6674A-11

S E R V I C E N O T E

**6674A - DC POWER SUPPLY, 0-60 V, 0-35 A, 2100 W.
GPIB. CONTROLLED**

Serial Numbers: MY41000101/ MY41002602 SG41000101/ SG41000573

Situation:

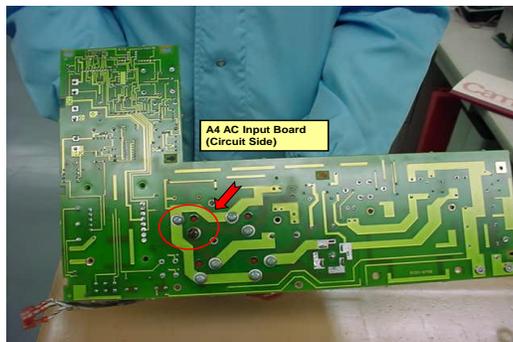
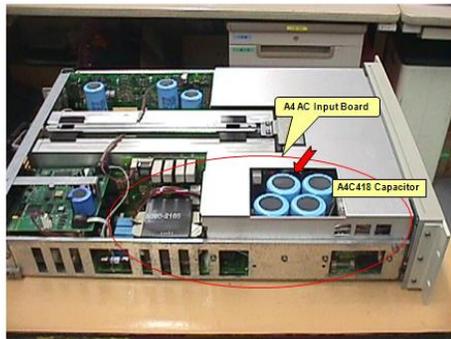
The four filter capacitors circuit reference (C416-C419) on the A4 AC input board starts leaking electrolyte - not through the pressure valve in the bottom as one would expect but through one of the terminal screw bushings.”

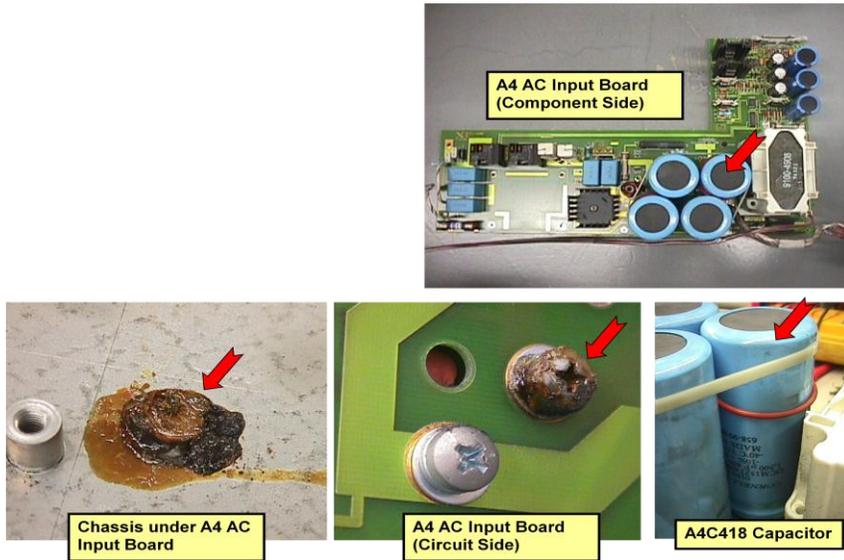
The screw P/N 2680-0217 length currently being used was not considered and the length was overlooked. The screw length is 0.375 inches long. We have found that the screw can be 0.055 inches too long and may bottom out causing the tapped hole in the header of the capacitor to become cracked or become broken.

When this happens the electrolyte will slowly leak out over time, and cause the defect described. This situation is even worse due to the capacitor is mounted with the header face down. If the capacitor was mounted header face up a cracked or broken header would not have caused this problem, the electrolyte could not leak out.

1. All affected models and tested assemblies WIP (Work In Process), FGI (Finished Goods Inventory) at SPO (Support Parts Organization) & AMC (Asian Manufacturing Center) has been inspected for capacitors with damaged headers due to the incorrect screw
2. When this repair is being done all of the hardware described above should be replaced (It is NOT recommended that any of the hardware be reused)
3. The following figures can be used when doing the repair.
4. Inspect the assembly as described below.
5. The last figure will aid in the reassembly of the hardware and the capacitors.
